DESIGN REVIEW BOARD RECOMMENDATION MEETING | CAPITOL HILL TOD

SECOND EAST DESIGN REVIEW BOARD MEETING ON OCTOBER 11, 2017

FIRST RECOMMENDATION MEETING PRIORITIES & BOARD RECOMMENDATIONS

RECOMMENDATION 1 | COMPOSITE LANDSCAPE/HARDSCAPE PLAN - GROUND PLANE | PUBLIC REALM

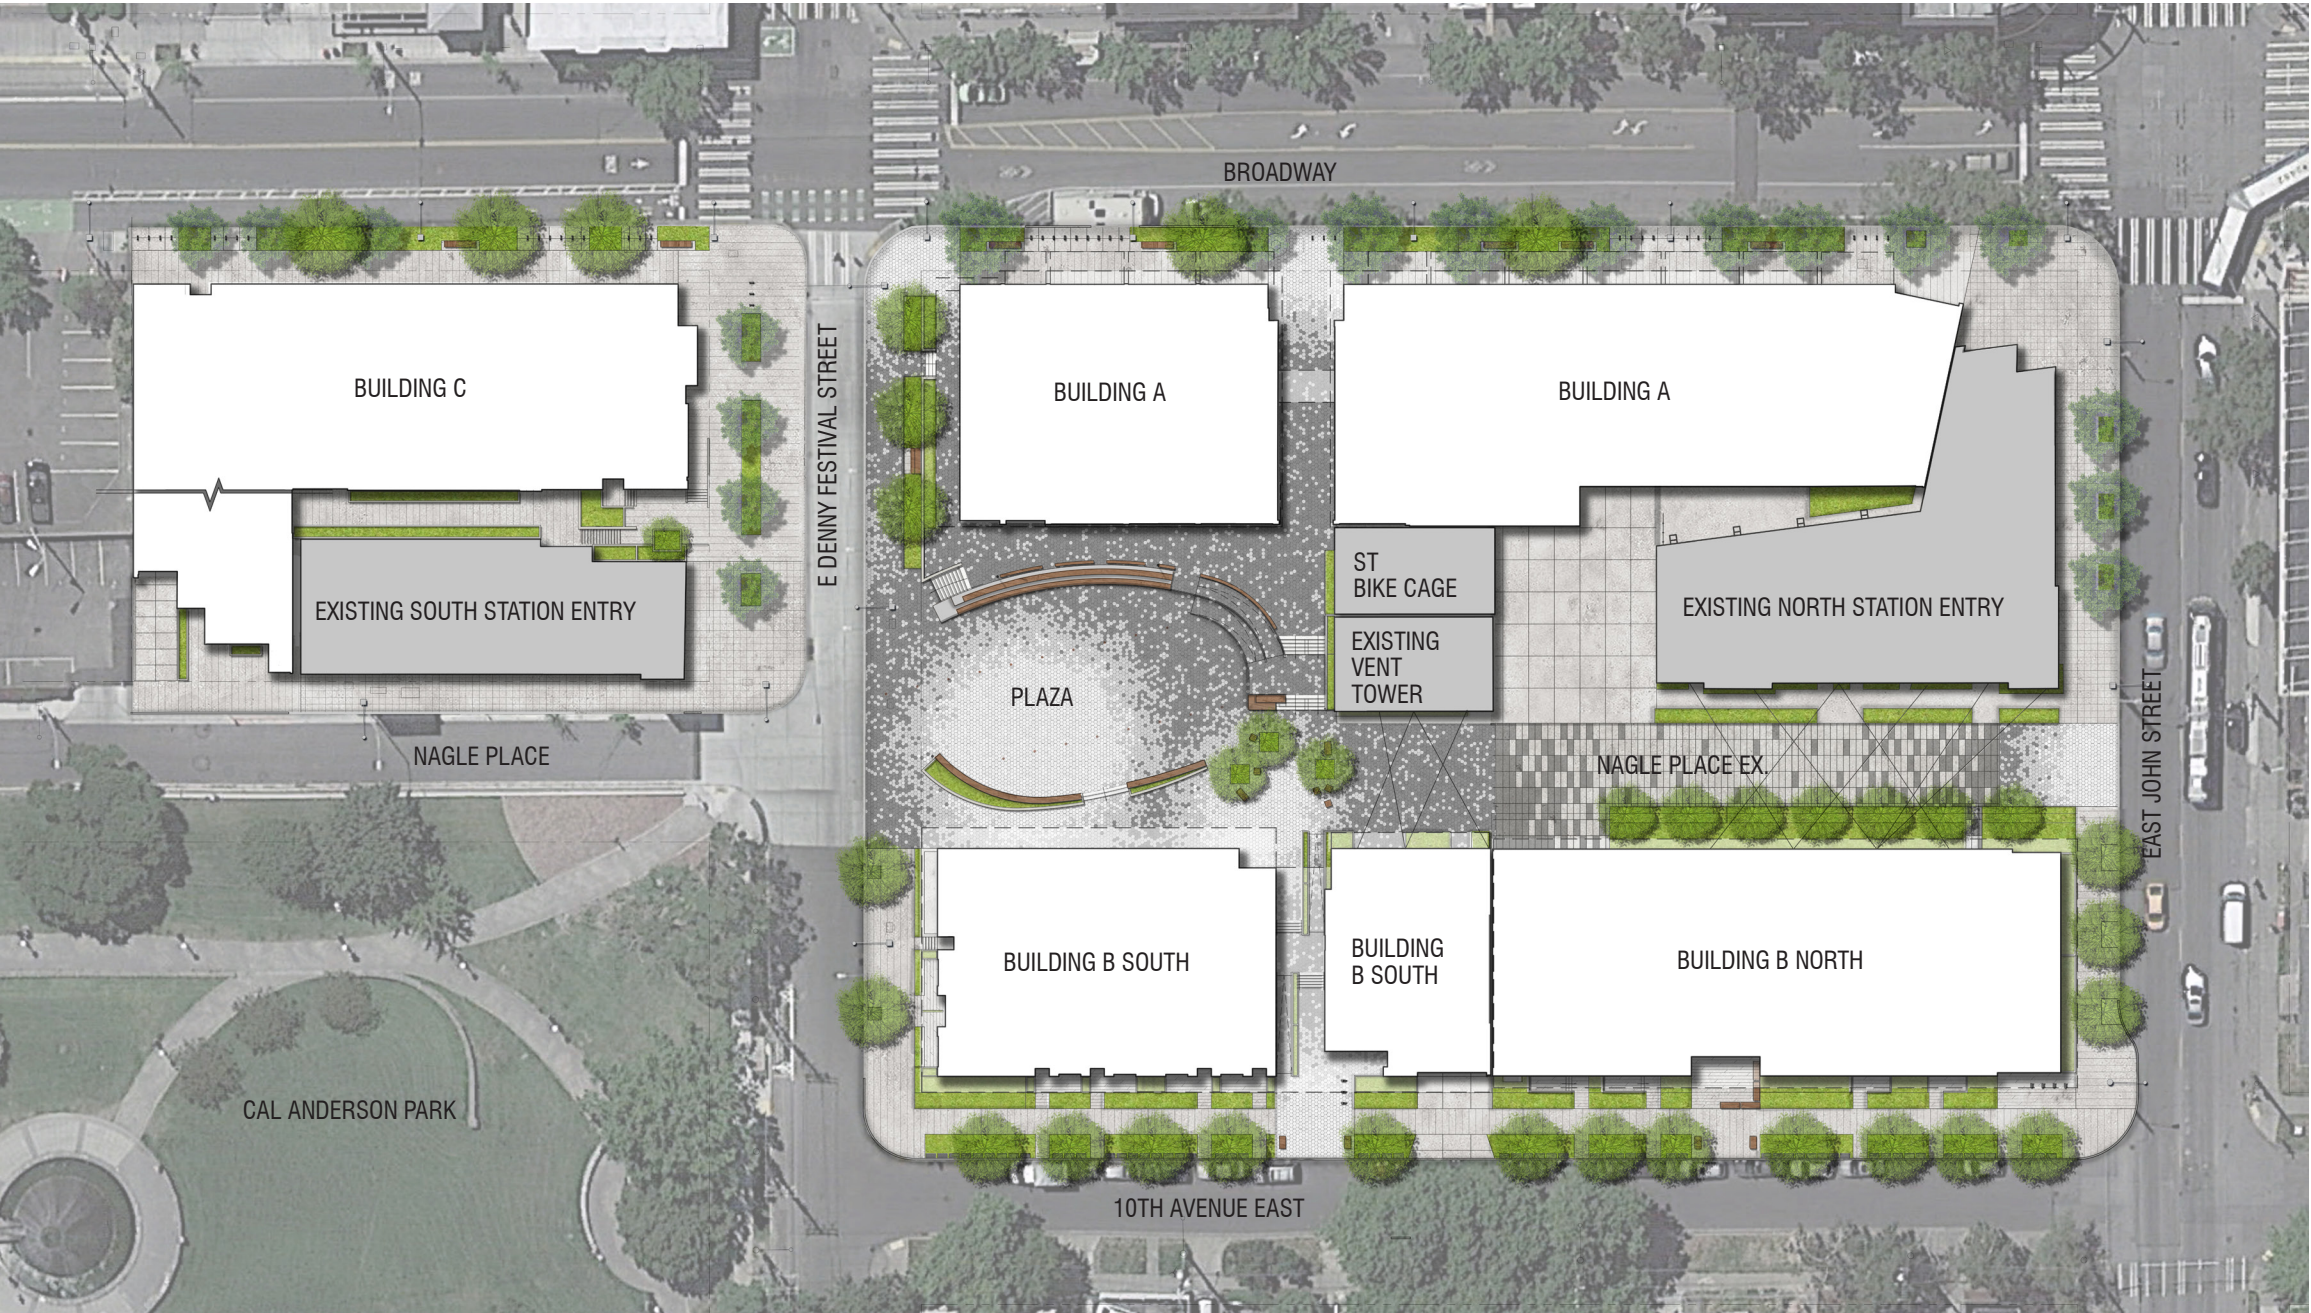
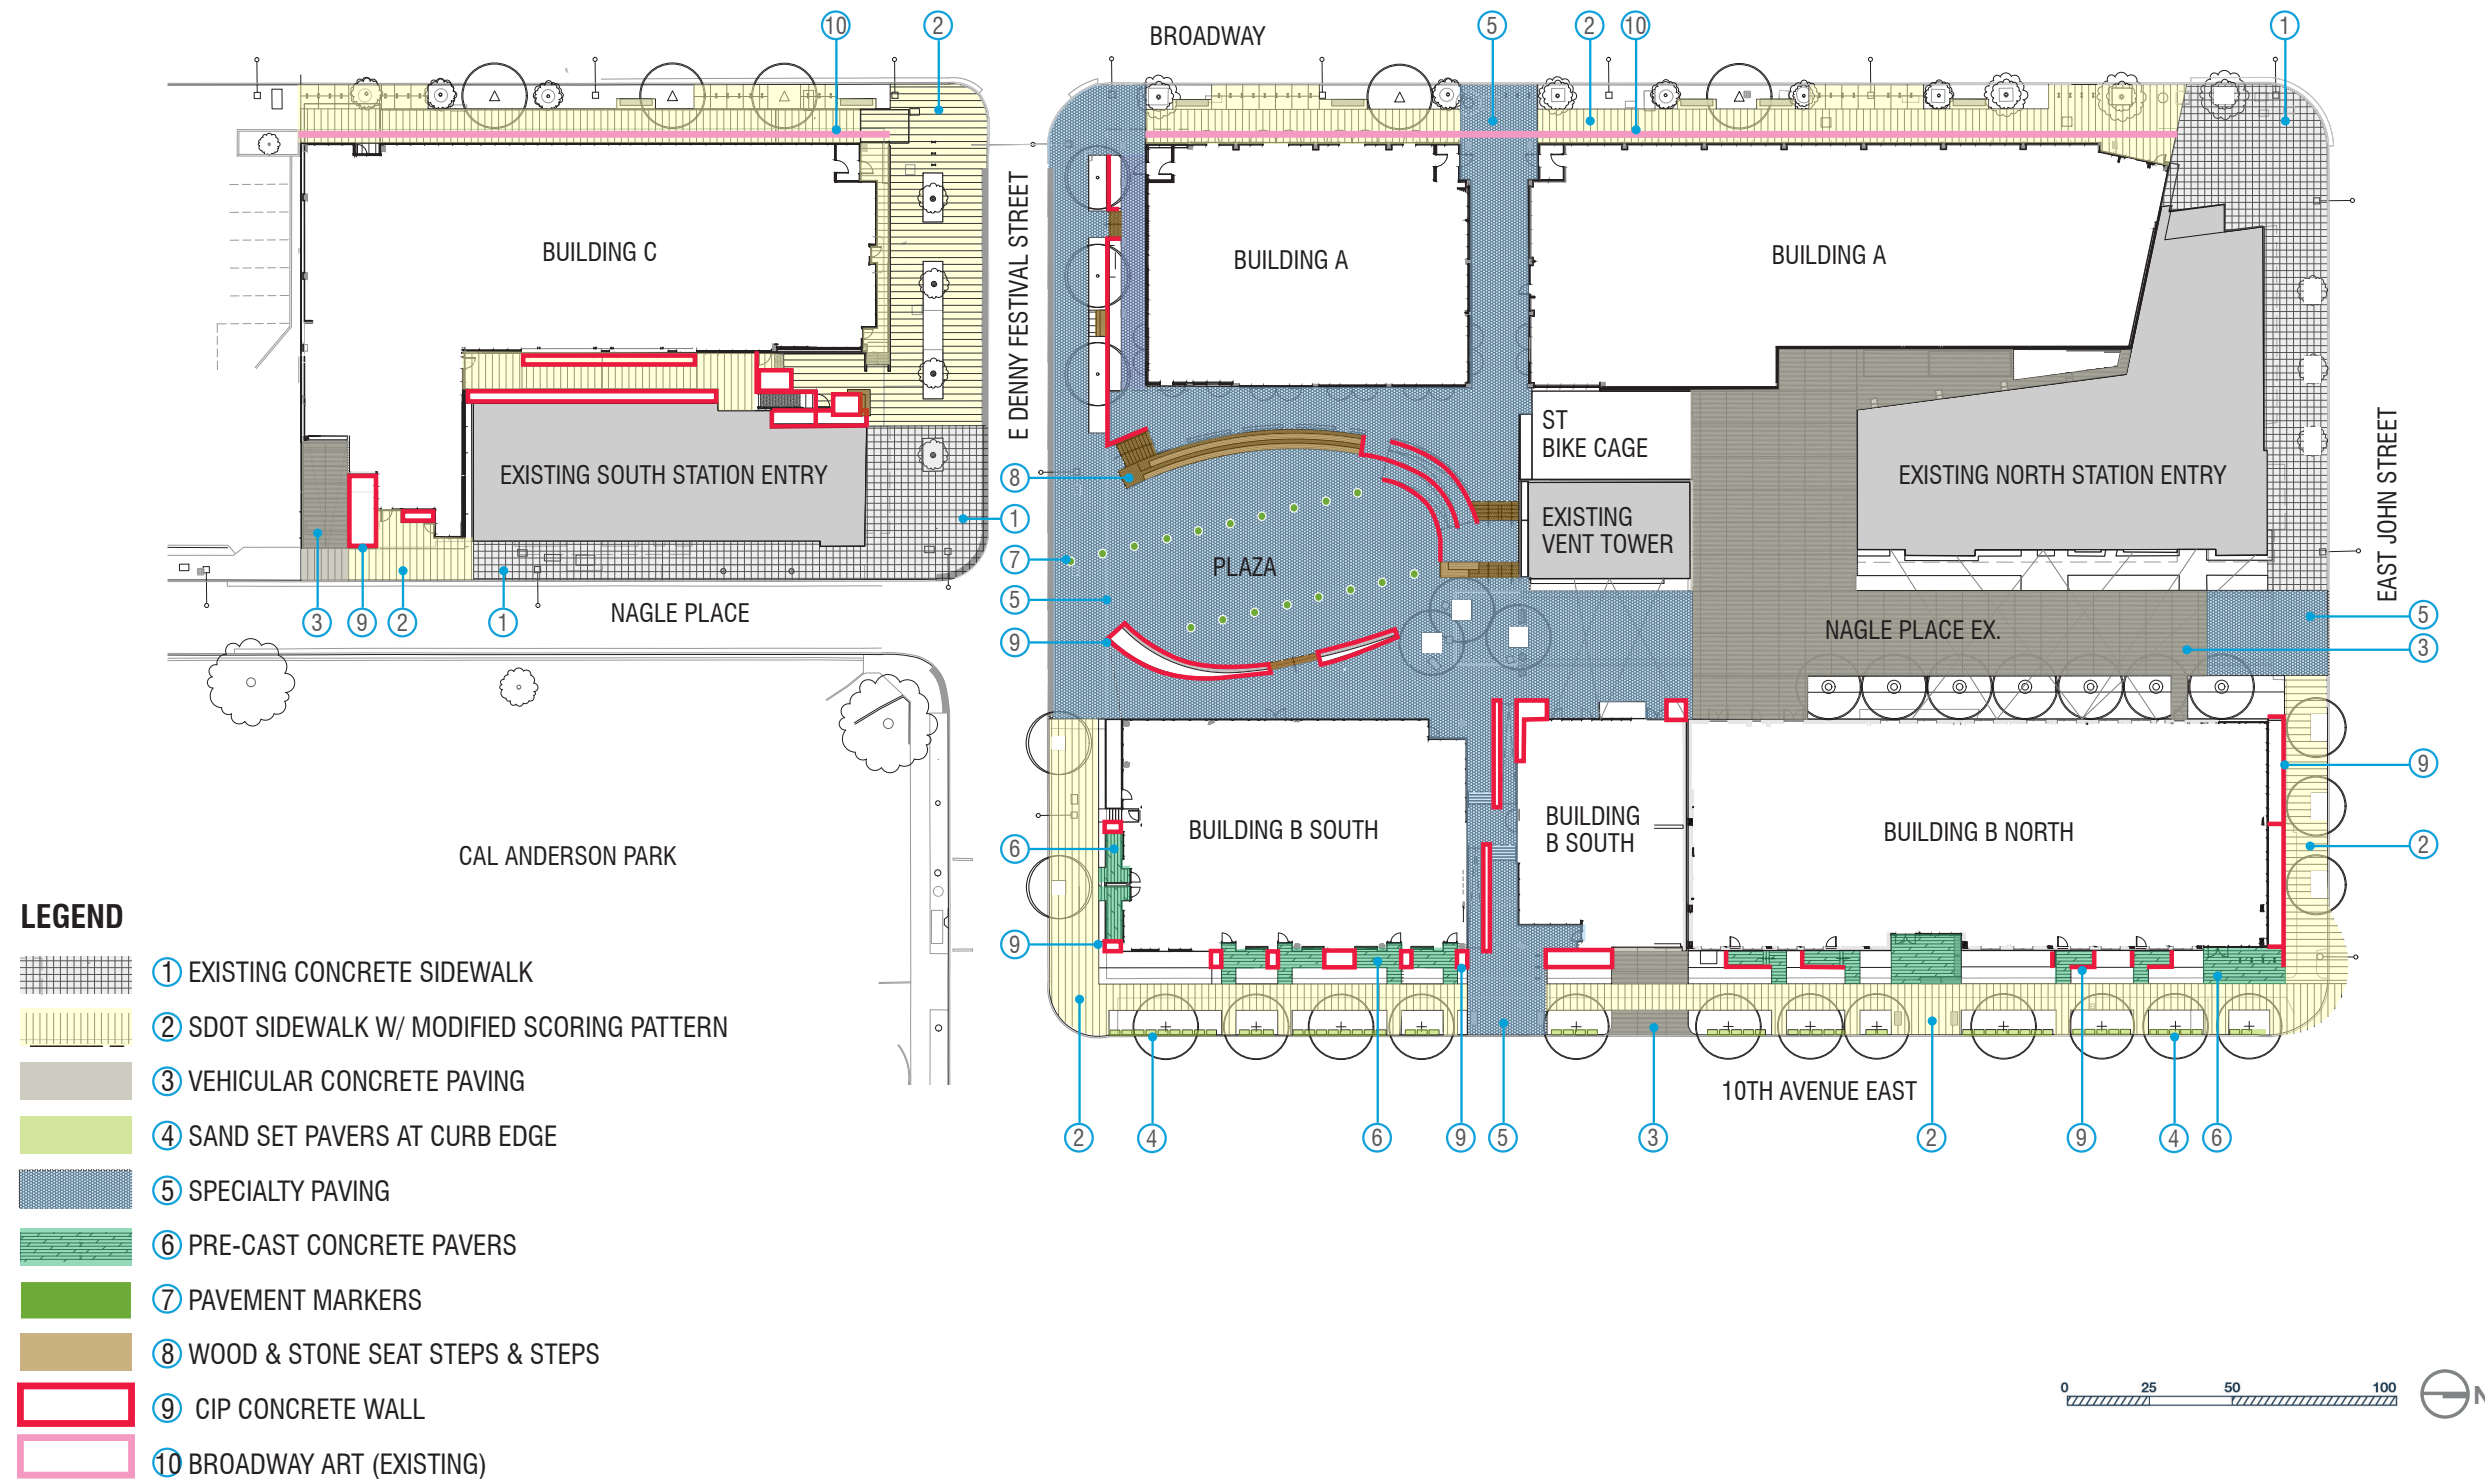
The Board again discussed this public realm element at length; it is a private driveway providing vehicle access to Site A and Sound Transit facilities. It is also accommodating sizable pedestrian and bike flows to the station, plaza and Cal Anderson Park. The south portion will be an occasional expansion of the plaza. The Board ultimately recommended that the NPE drive aisle be treated similarly to the plaza treatment to emphasize pedestrian realm over the vehicle. (DC1-S-I; DC3-S-V-iv; DC4-D-4)

RESPONSE:
Nagle place extension is being proposed to remain cast in place concrete for durability (as shown during the first recommendation meeting); however, an integral color with a smaller joint pattern and a gradation to relate to the specialty pavers has been introduced to provide a more pedestrian-friendly appearance.
